Denver Union Station Redevelopment

Public Presentation on Transit Architecture | July 16, 2009

Public Comment on Transit Architecture

Circulation – Mall Shuttle

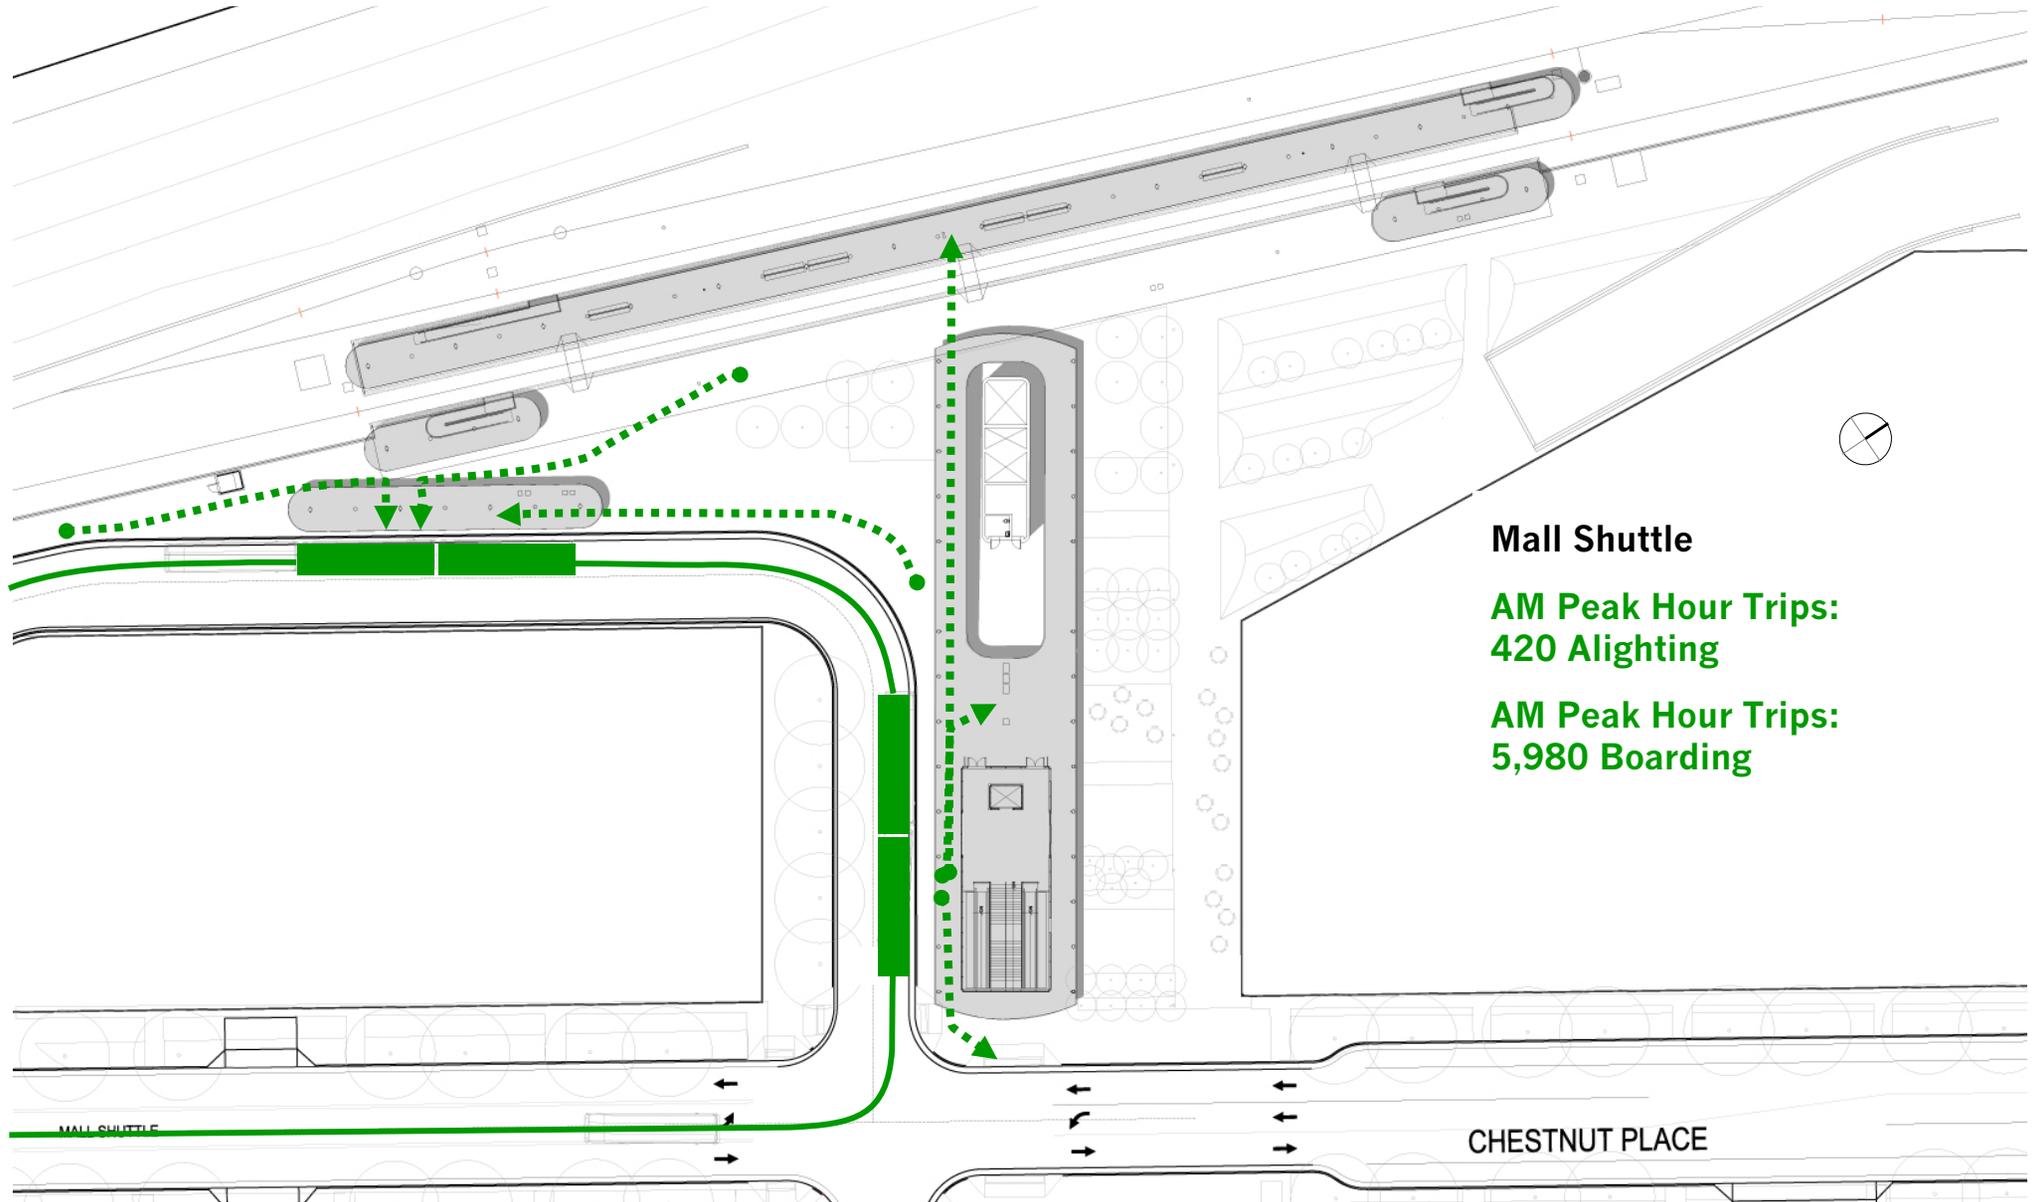
- Add more stops for the shuttle.
- Move 16th & Wewatta stop to align with CRT public concourse.
- Add a stop for every block in the CPV, similar to Downtown and LoDo in the rest of the system.
- Extend loop to open up access to north side of the Valley/Prospect neighborhood and enhance access to regional buses.

- Per RTD, changes to the planned route and stops are not contemplated at this time.

LRT Architectural Design

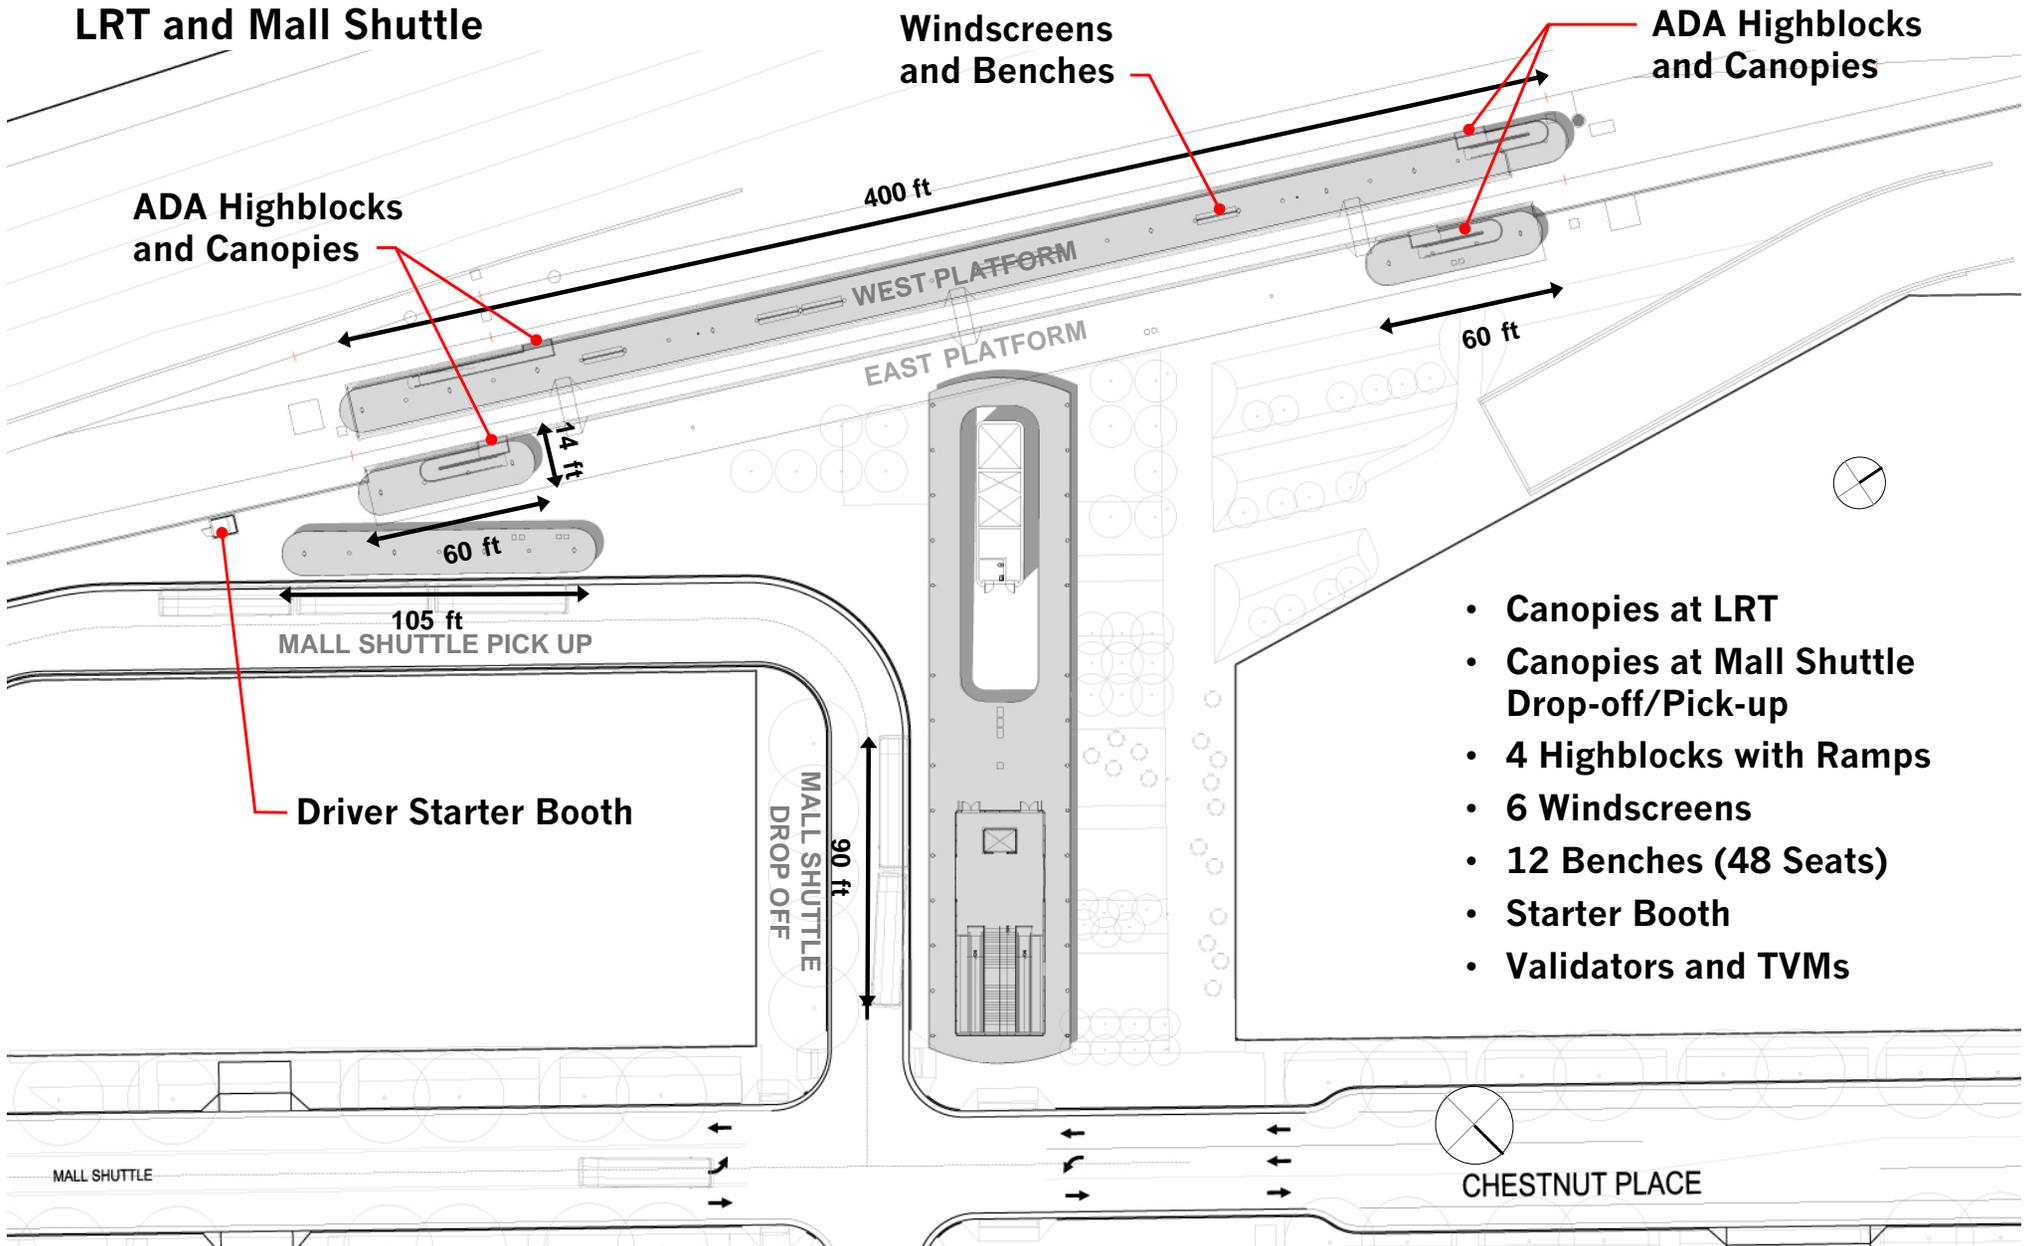
- There has been no public review of any design for the LRT. Is it important that that design be presented to and evaluated by the public.
- To maximize the TOD development opportunities on Blocks 15 & 17, it is important to develop a unique destination place and arrival experience as a transit station.

- Agreed. New presentation material is available.

On-street Parking

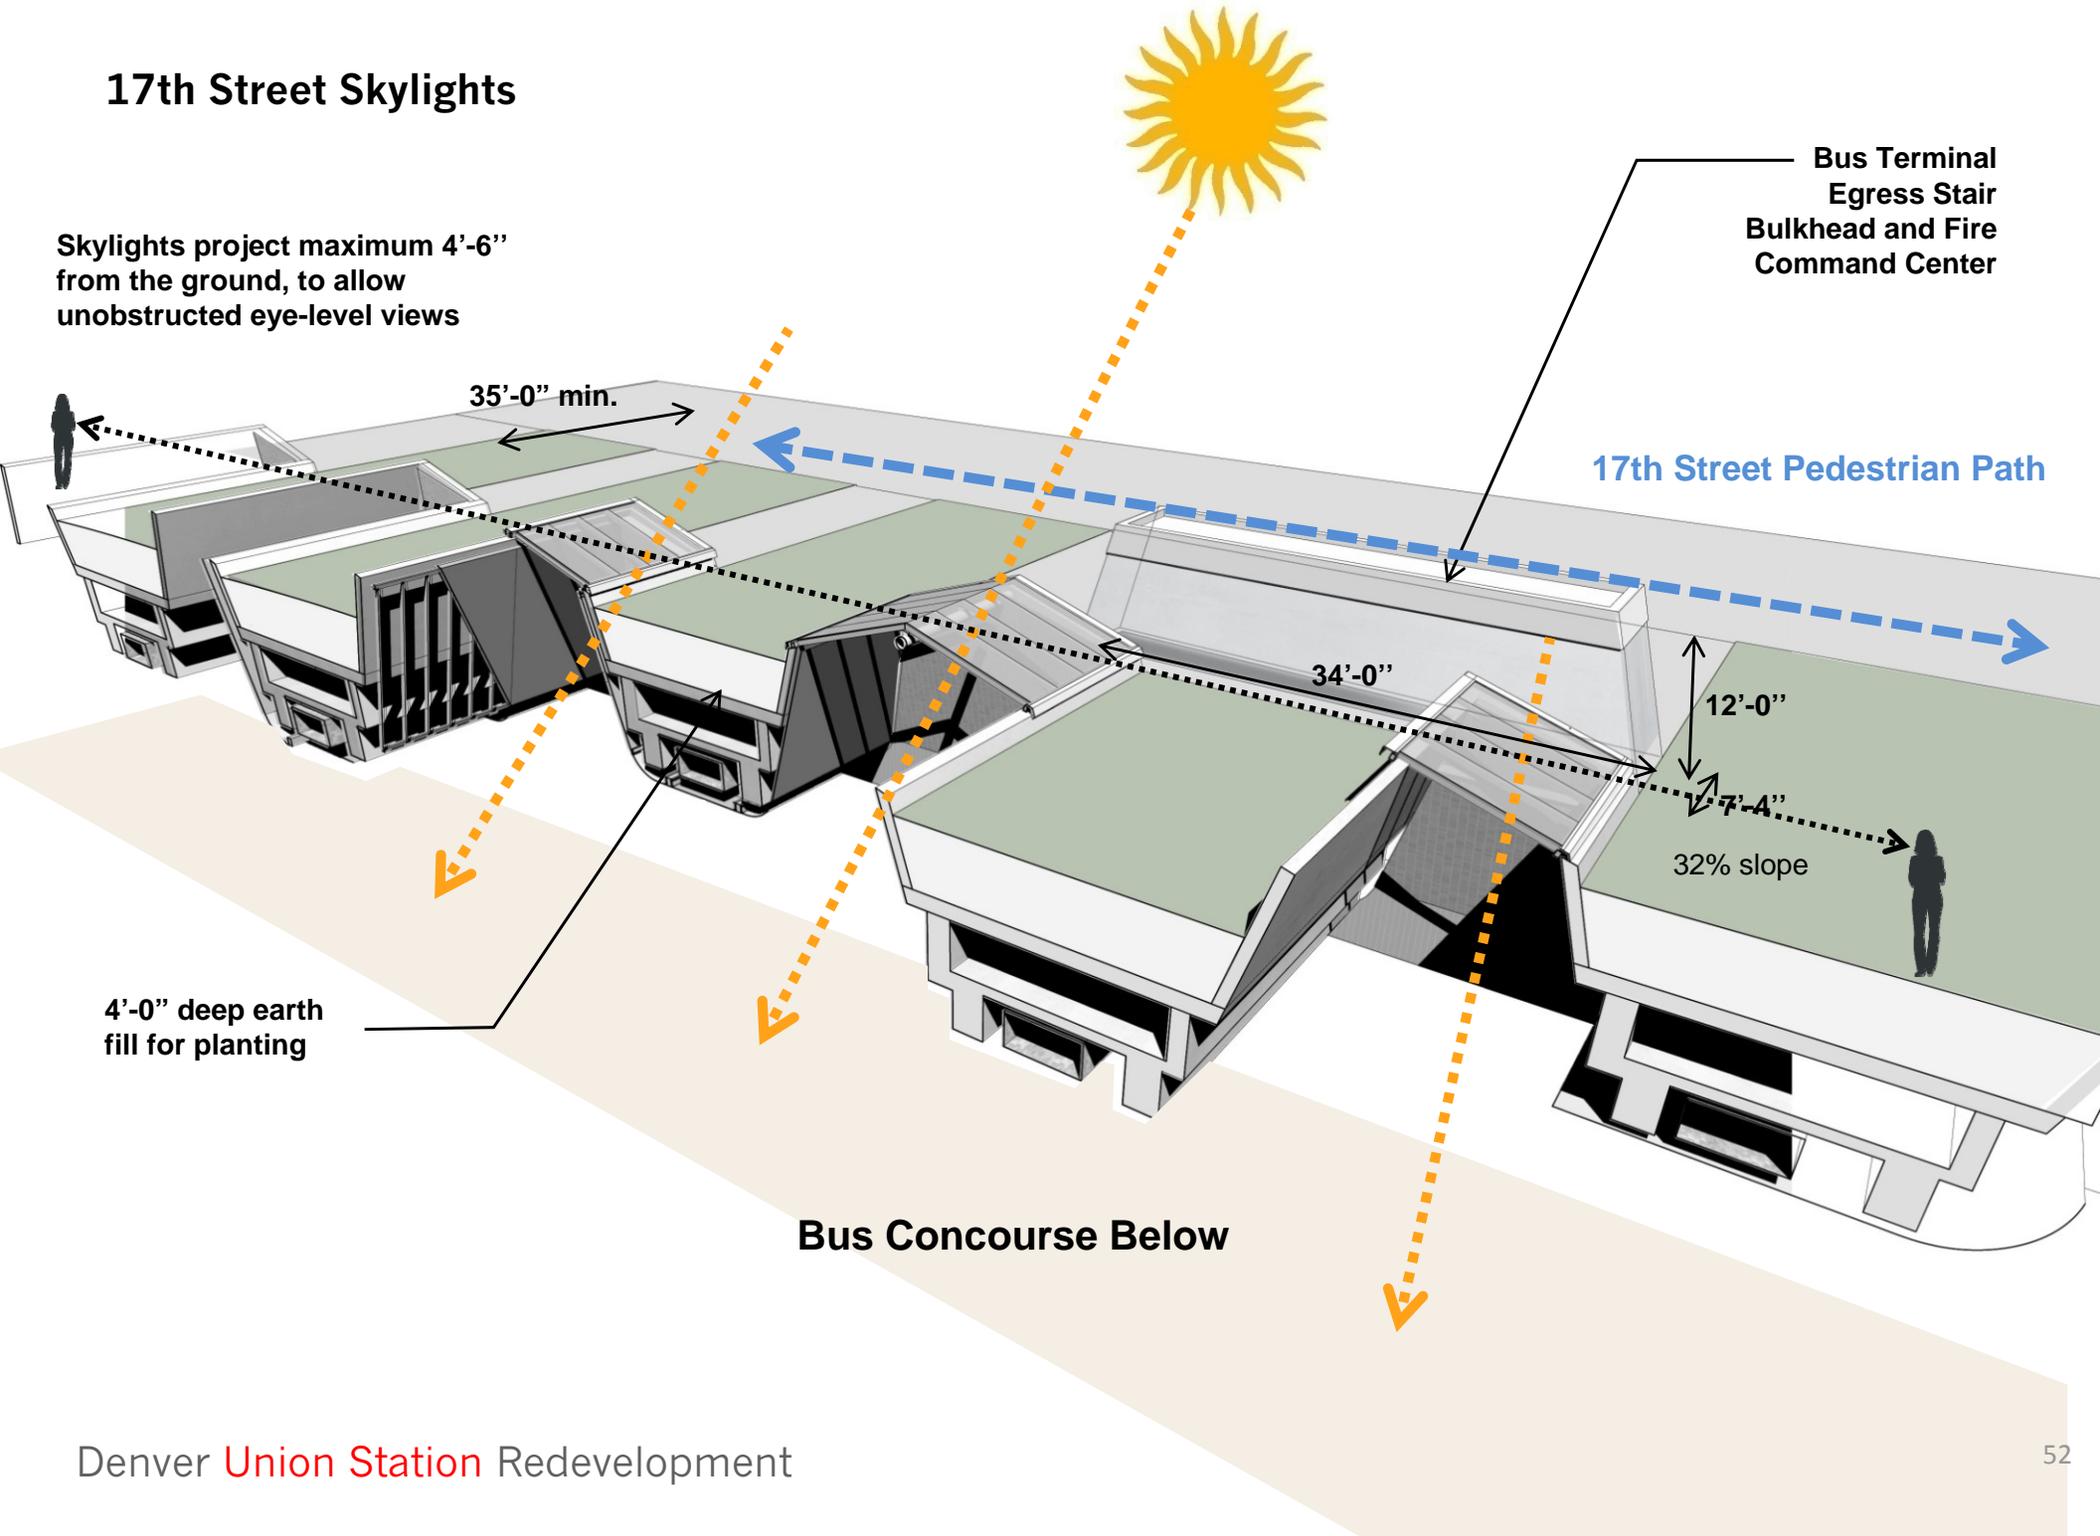
- Delete the northern row of parking in the 17th Street ROW to improve accessibility to the public “rooms” of the 17th Street linear park and to maintain an axial view and walkway to the station.

- Project leadership intends to provide as much on-street parking as possible to support retail.
- Design Team will investigate opportunities to refine the cross-section of the street.

Bus Station Architectural Design

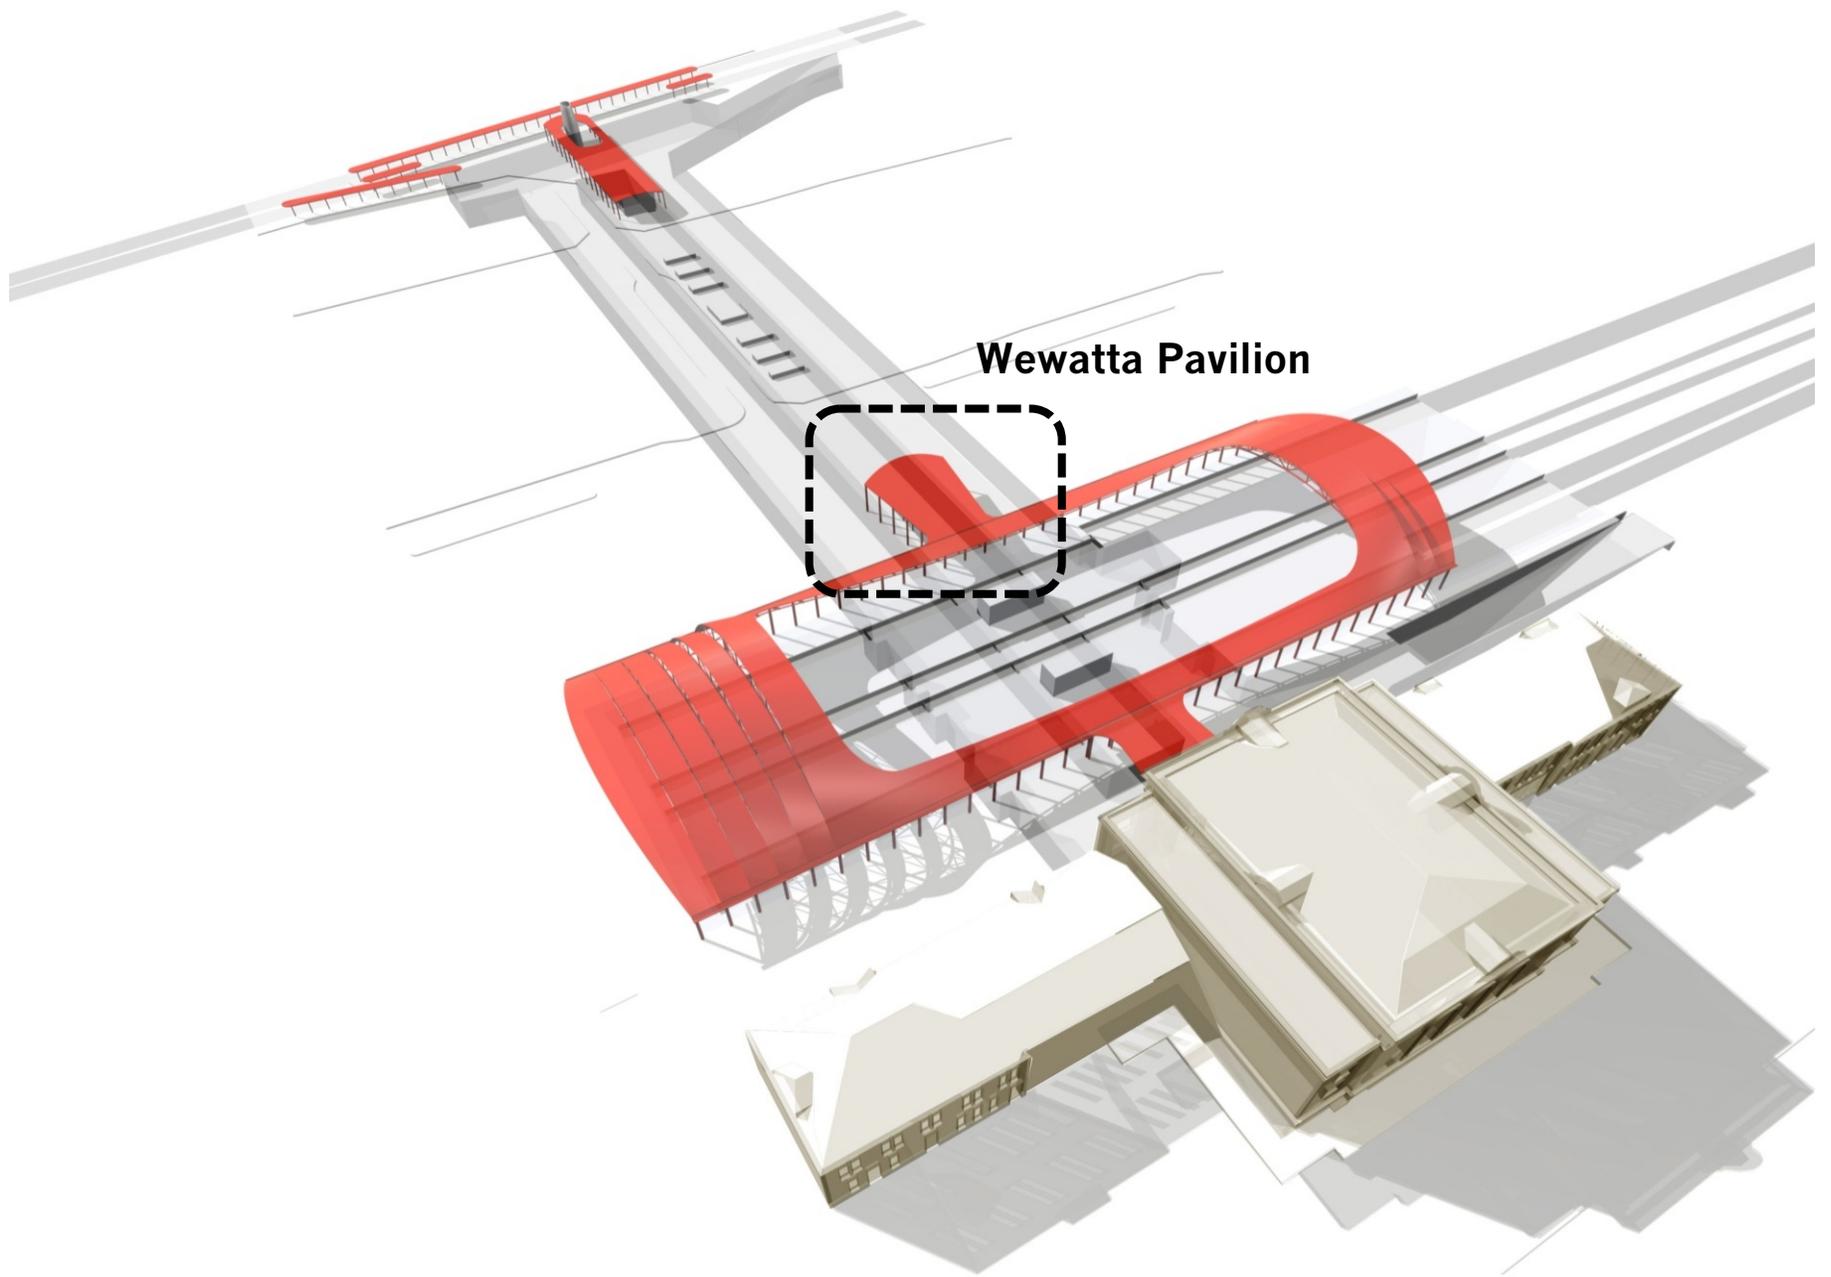
- The pedestrian environment within the bus box needs further development and presentation.

- Agreed.
